Re: NPDES Permit No. IN0063711
ArcelorMittal Indiana Harbor, LLC –
Central Wastewater Treatment Plant
East Chicago, Indiana
Lake County

A response to the comments received pertaining to the draft NPDES permit is contained in the Post Public Notice Addendum. The Post Public Notice Addendum is located at the end of the Fact Sheet.

INDEX
for
ArcelorMittal Indiana Harbor Central Wastewater Treatment Plant NPDES Permit IN0063711

ARCELORMITTAL INDIANA HARBOR LLC – CENTRAL WASTEWATER TREATMENT PLANT

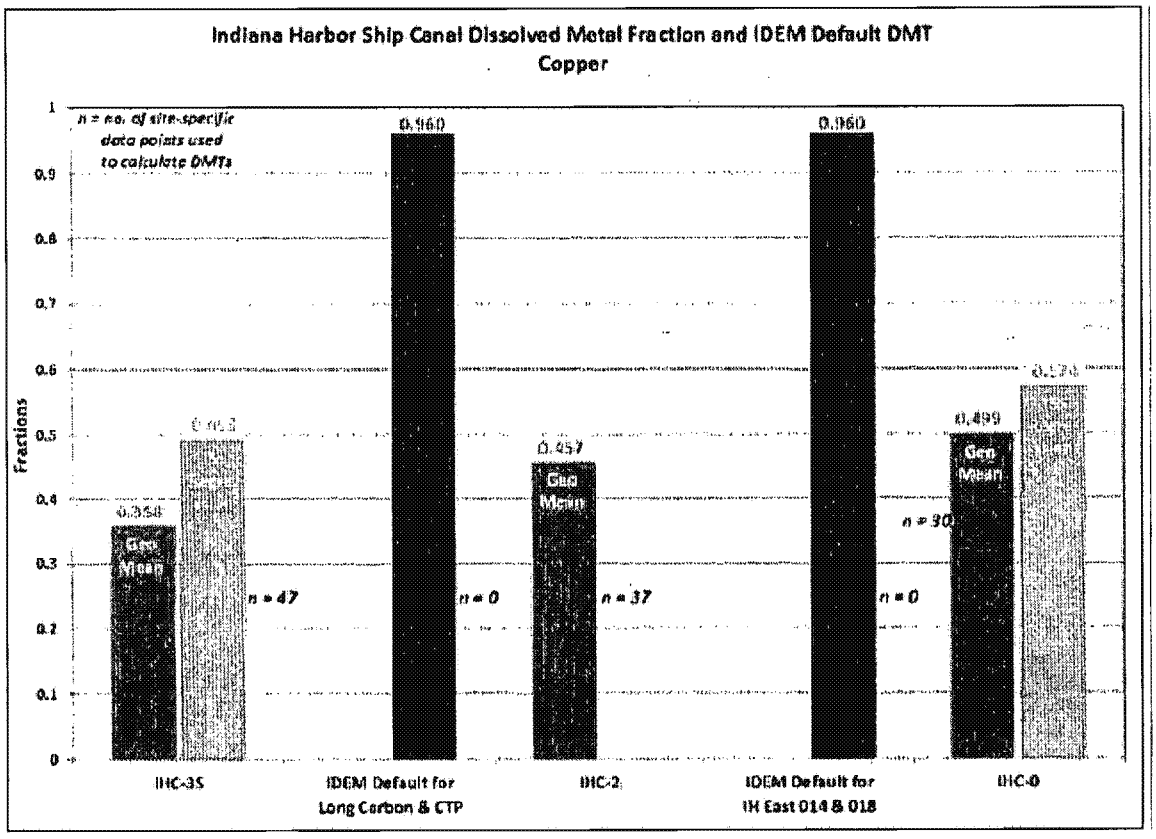
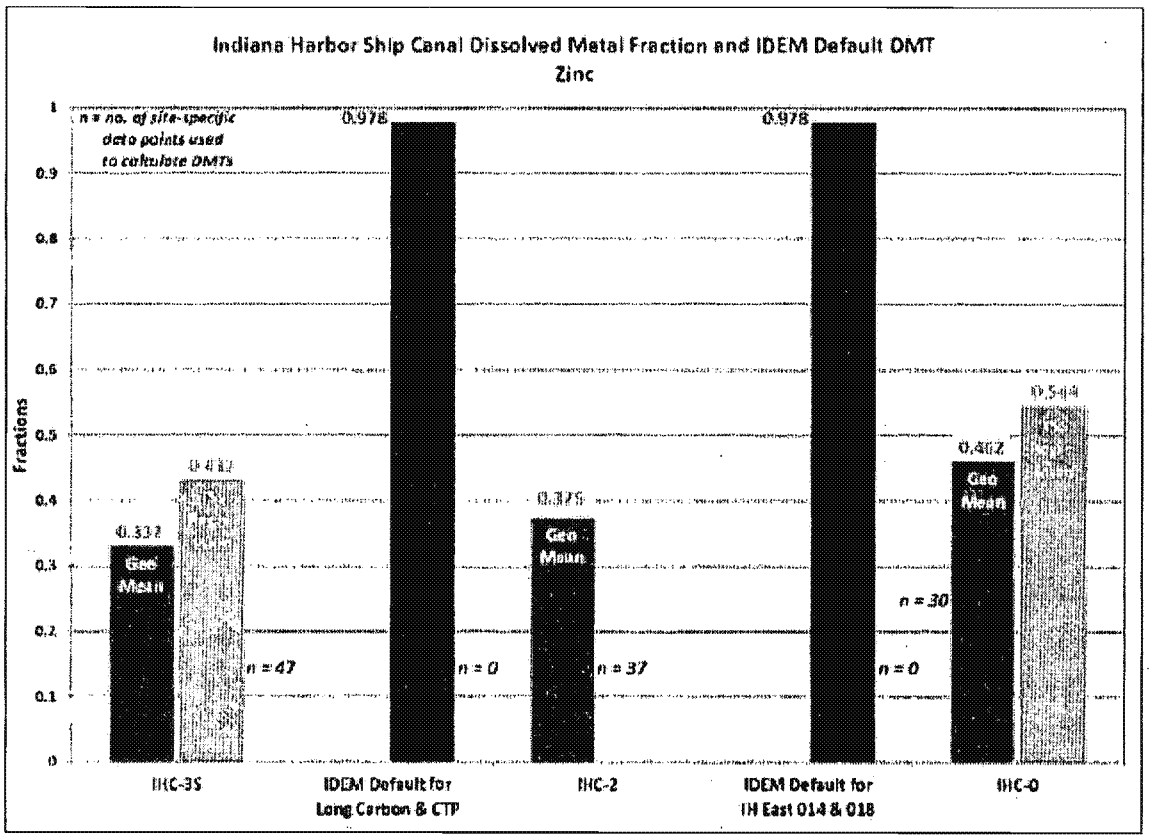
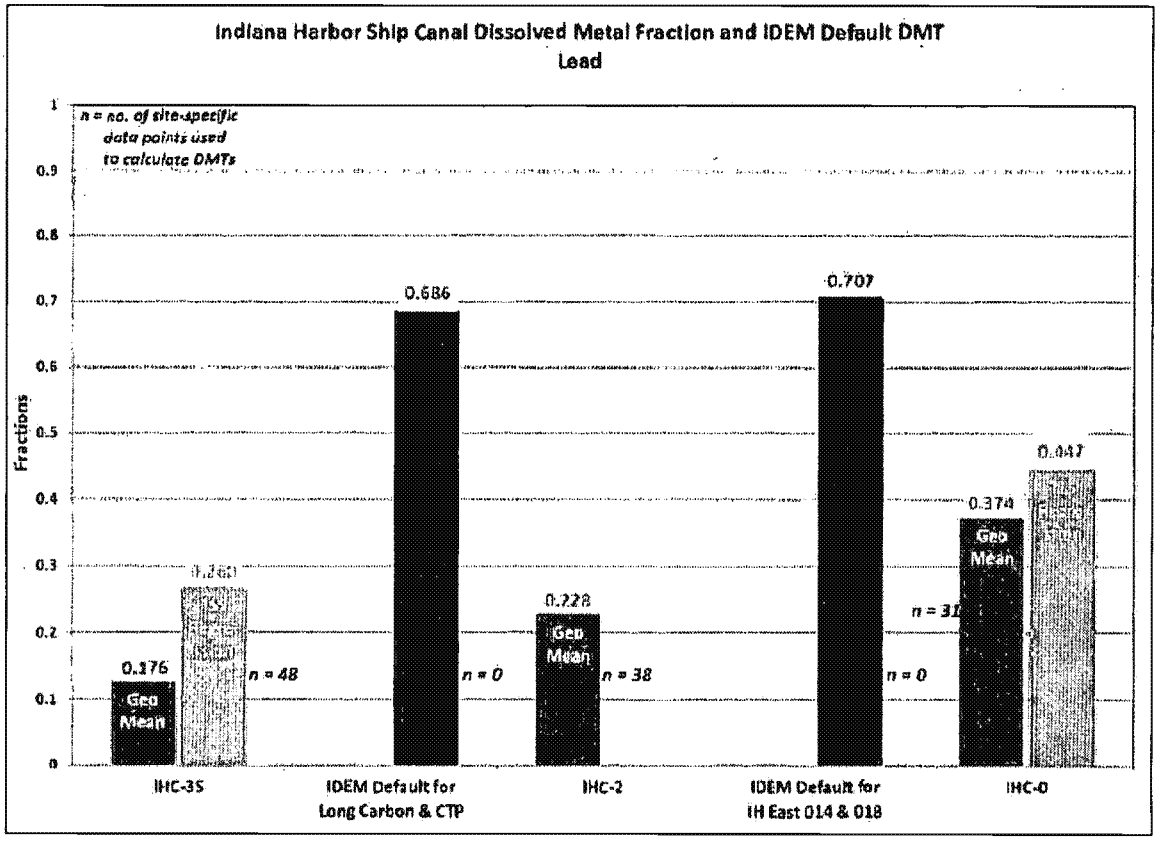
IDEM's default DMTs, which rely on no data specific to the IHSC, are clearly inaccurate for the ArcelorMittal permits and overestimate the dissolved copper, lead and zinc fractions in the IHSC by significant amounts. For example, the default translators are 2.1, 3.0 and 2.6 times greater than the calculated geometric mean of the dissolved fractions for copper, lead and zinc, respectively, at IHC-2. Even the 95th percentiles of the dissolved fractions for all metals at all locations are significantly below IDEM's default translators. As shown, the DMTs calculated at IHC-3S, IHC-2 and IHC-0 are considerably lower than IDEM's default DMTs used in the calculation of WQBELs. Graphs of the geometric mean dissolved fractions, TSS-regression developed DMTs, and IDEMs default DMTs are presented below.

Given the data presented in the table and graphs above, it is not reasonable to assume, as IDEM has done through use of the default DMTs, that the dissolved metal fraction in the water column somehow increases dramatically in between the fixed monitoring stations. ArcelorMittal's requested effluent limits, based upon site-specific DMTs derived from the IDEM fixed monitoring station data and other factors, are presented below.

1. WATER QUALITY-BASED EFFLUENT LIMITS (WQBELs)

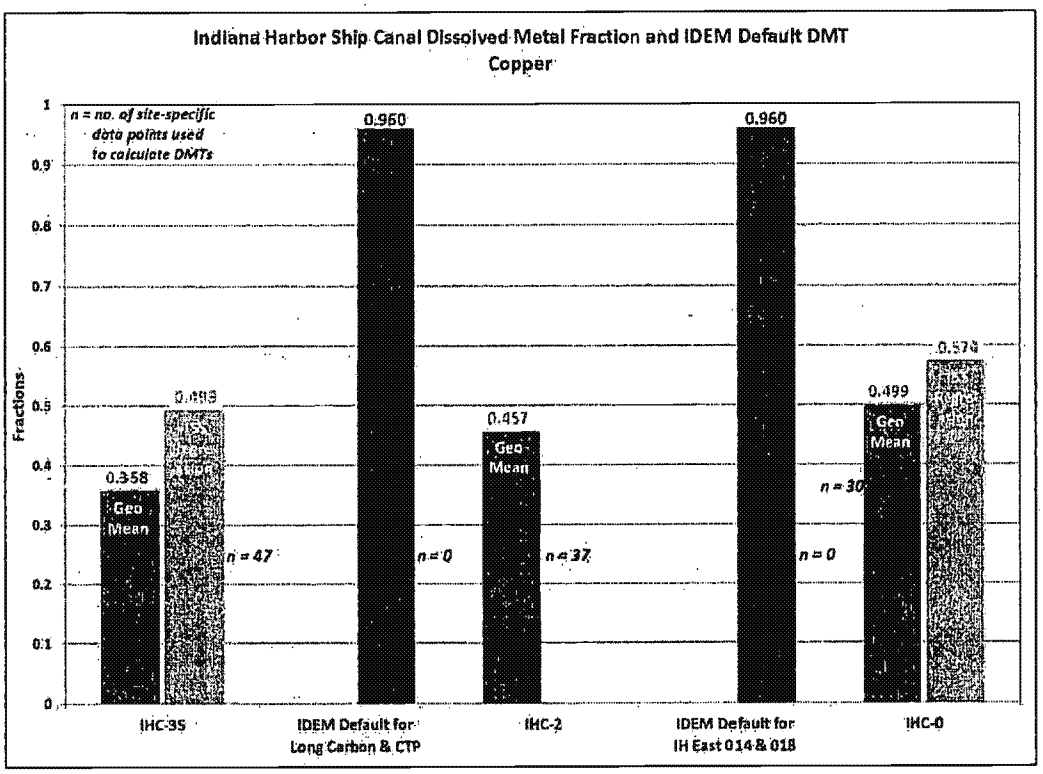
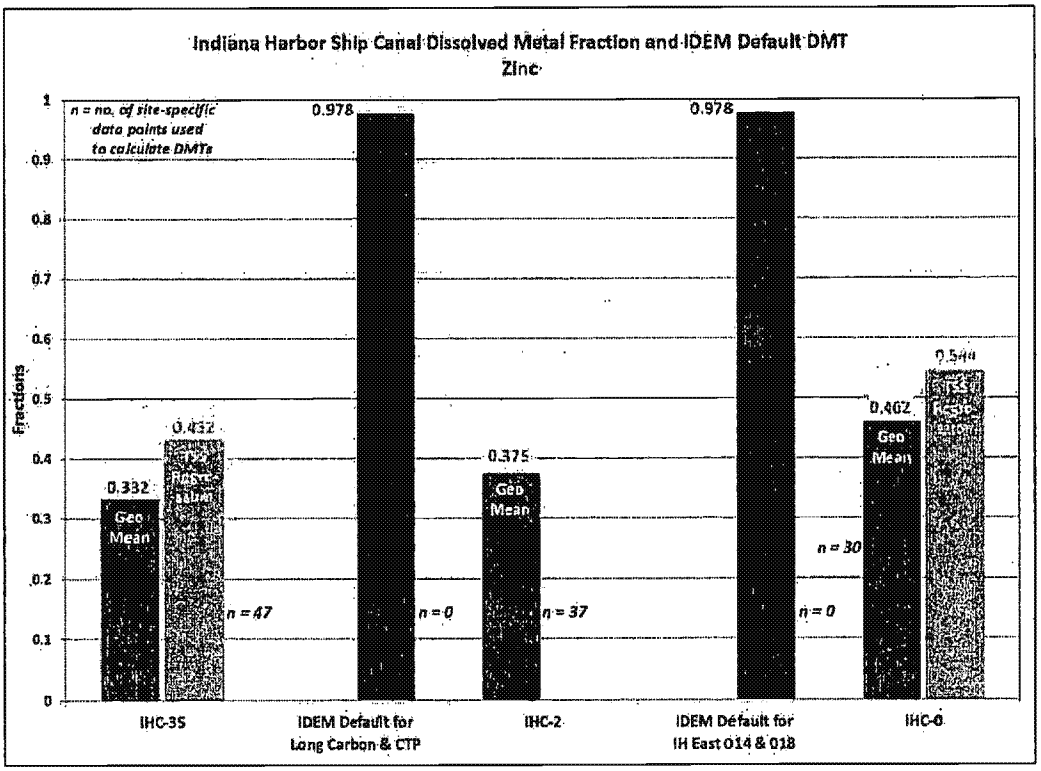
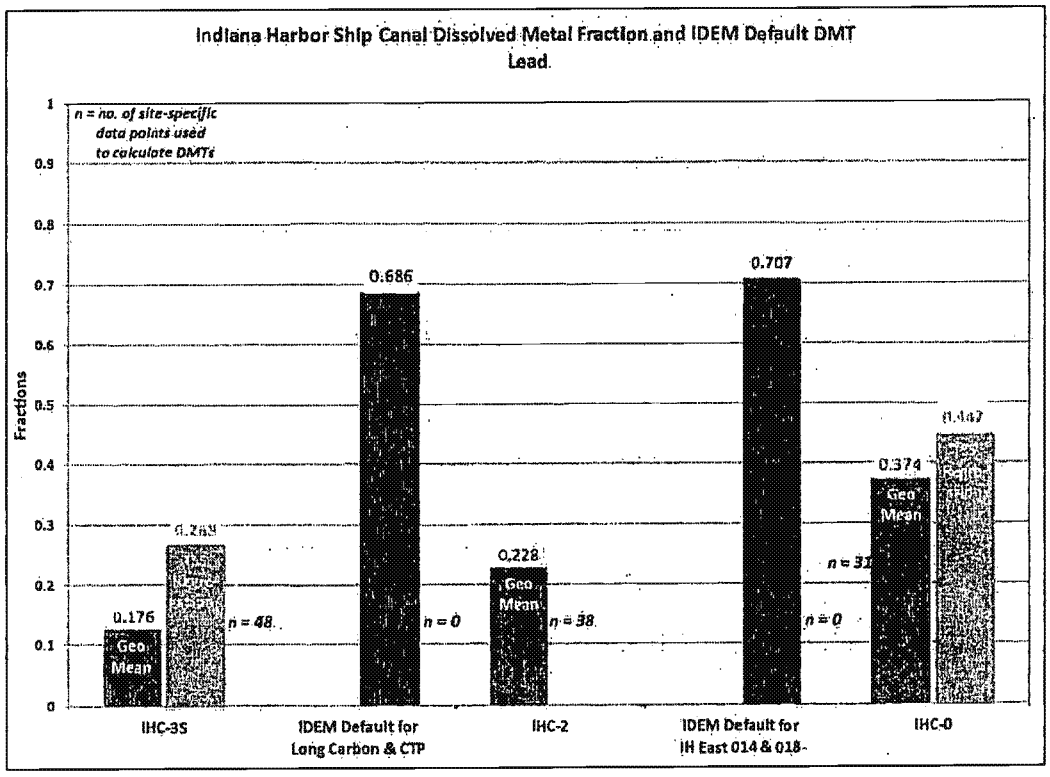
IDEM's default DMTs, which rely on no data specific to the IHSC, are clearly inaccurate for the ArcelorMittal permits and overestimate the dissolved copper, lead and zinc fractions in the IHSC by significant amounts. For example, the default translators are 2.1, 3.0 and 2.6 times greater than the calculated geometric mean of the dissolved fractions for copper, lead and zinc, respectively, at IHC-2. Even the 95th percentiles of the dissolved fractions for all metals at all locations are significantly below IDEM's default translators. As shown, the DMTs calculated at IHC-3S, IHC-2 and IHC-0 are considerably lower than IDEM's default DMTs used in the calculation of WQBELs. Graphs of the geometric mean dissolved fractions, TSS-regression developed DMTs, and IDEMs default DMTs are presented below.

Given the data presented in the table and graphs above, it is not reasonable to assume, as IDEM has done through use of the default DMTs, that the dissolved metal fraction in the water column somehow increases dramatically in between the fixed monitoring stations. ArcelorMittal's requested effluent limits, based upon site-specific DMTs derived from the IDEM fixed monitoring station data and other factors, are presented below.

FIGURE IHW-1

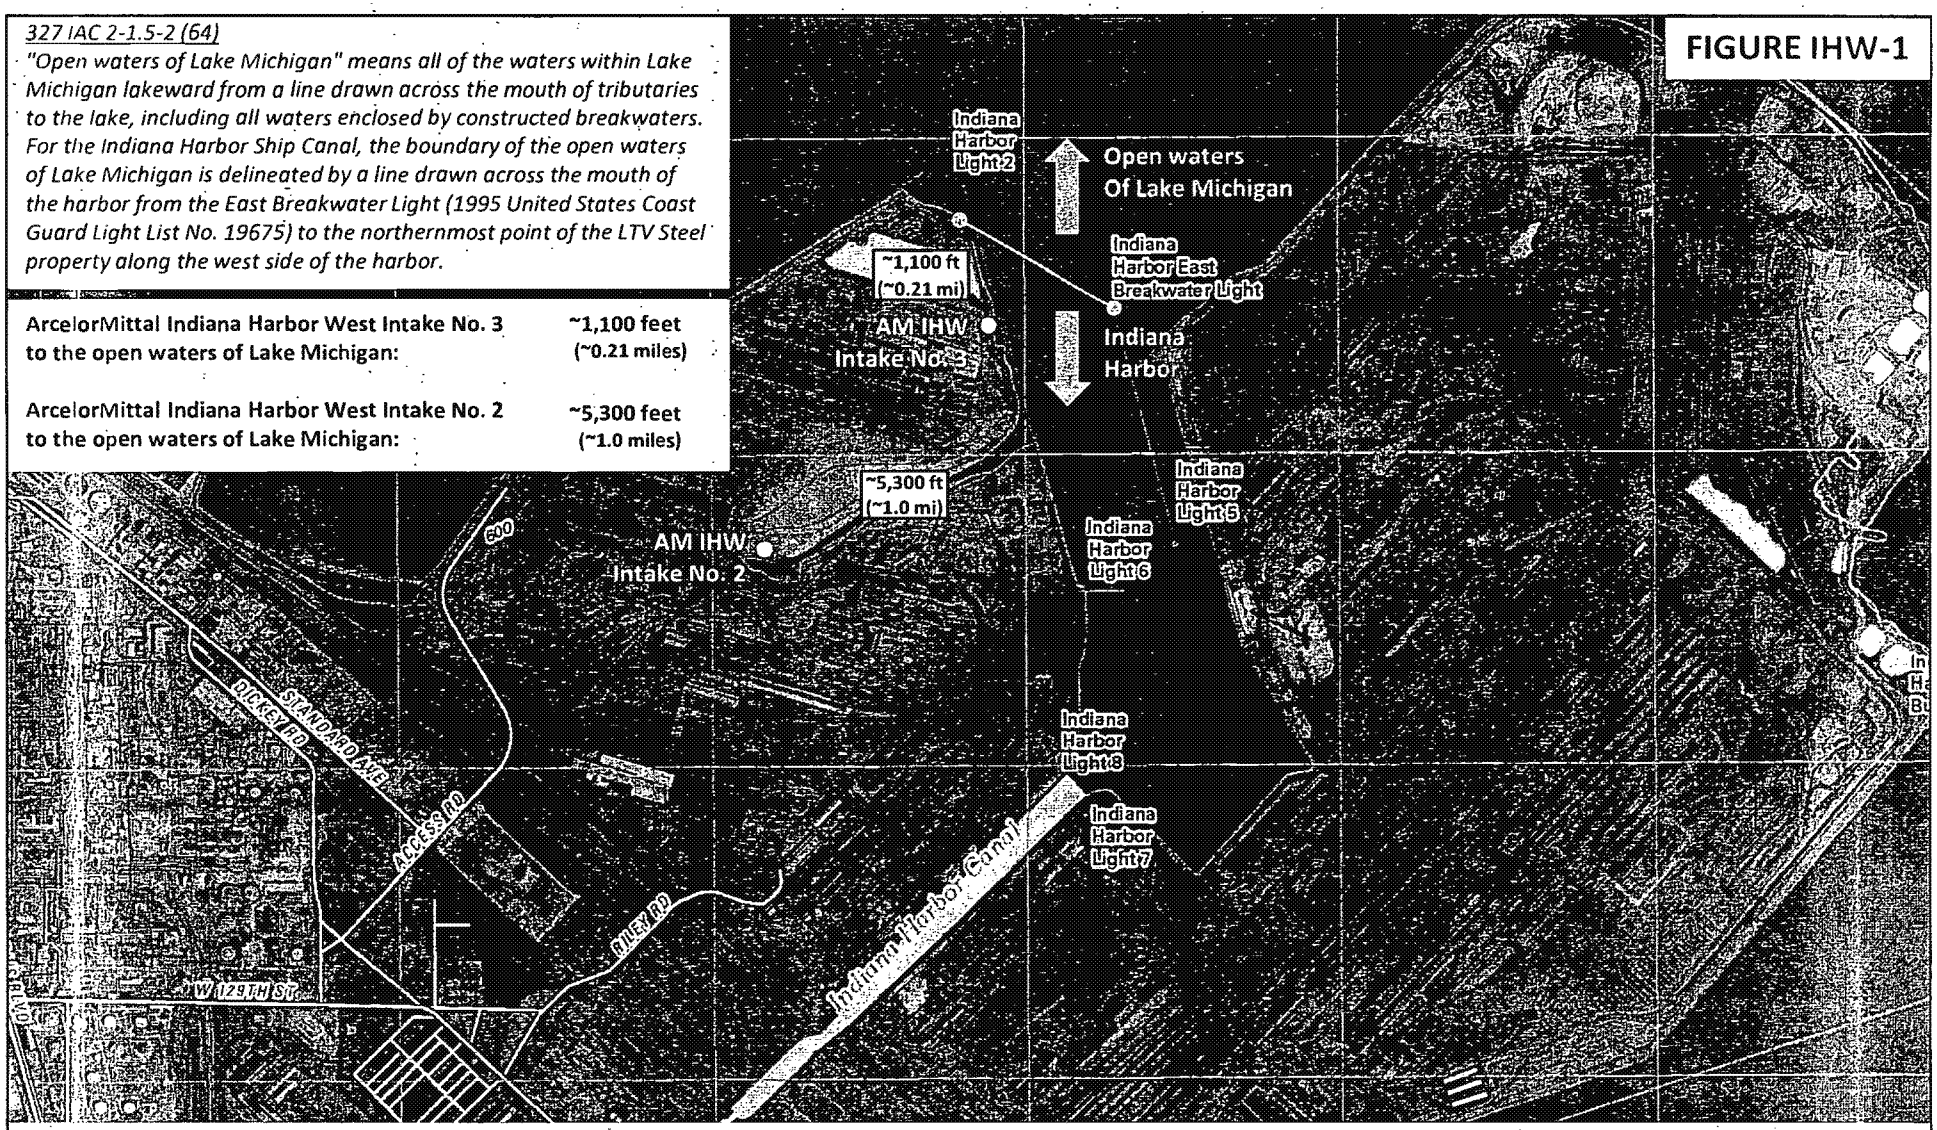
IDEM states in Attachment A of the Fact Sheet (p. 5), that Indiana Harbor West has two water intakes in Lake Michigan; and, that IDEM considers the intake channel for the Nos. 2 and 3 intakes as "open waters of Lake Michigan" (p. 12). Figure IHW-1 is an aerial photograph showing the Nos. 2 and 3 intakes, the intake channel and the northern section of the Indiana Harbor Ship canal that borders the open waters of Lake Michigan. A line depicting the boundary described in the above definition of "open waters of Lake Michigan" is shown on the aerial photograph. It is evident from a simple reading of the regulatory definition of "open waters of Lake Michigan" and review of the aerial photograph that the Indiana Harbor West intake channel and the Nos. 2 and 3 intakes are not within open waters of Lake Michigan. They are not lakeward of the line between the East Breakwater Light and the northernmost point of LTV Steel property (now ArcelorMittal Indiana Harbor LLC property). In fact, the No. 3 Intake is approximately 0.21 miles south of the northernmost point of ArcelorMittal property and the No. 2 intake is approximately 1.0 miles south and southwest of the northernmost point of ArcelorMittal property. Thus, IDEM's assertion that the intake channel for the Nos. 2 and 3 intakes are within the

ArcelorMittal Indiana Harbor West Intake No. 3 to the open waters of Lake Michigan:	**~1,100 feet (~0.21 miles)**
ArcelorMittal Indiana Harbor West Intake No. 2 to the open waters of Lake Michigan:	**~5,300 feet (~1.0 miles)**
